## City of Mississauga Department Comments

Date Finalized: 2023-05-03 File(s): A113.23

**Property Address:** 1754 Riverbrook Cres

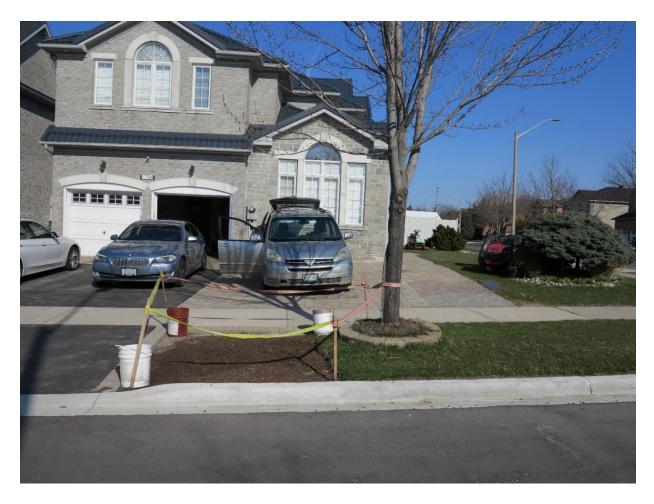
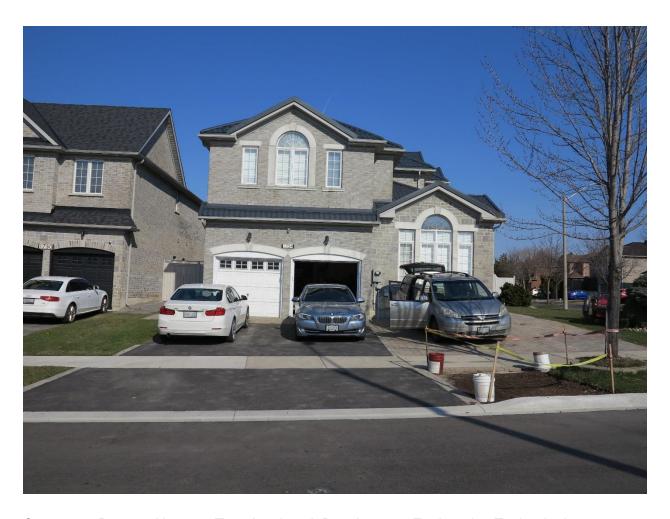
Planning staff remain of the opinion that the proposal represents a significant amount of hardscaping that is out of character for the surrounding area. Furthermore staff note that the

driveway would be able to accommodate the parking of more than three vehicles across, contrary to the intent of the zoning by-law.

Staff are of the opinion that, as currently proposed, the driveway does not meet the general intent or purpose of the official plan or zoning by-law, and is not minor in nature. Staff therefore recommend that the application be deferred in order to allow the applicant to redesign the driveway.
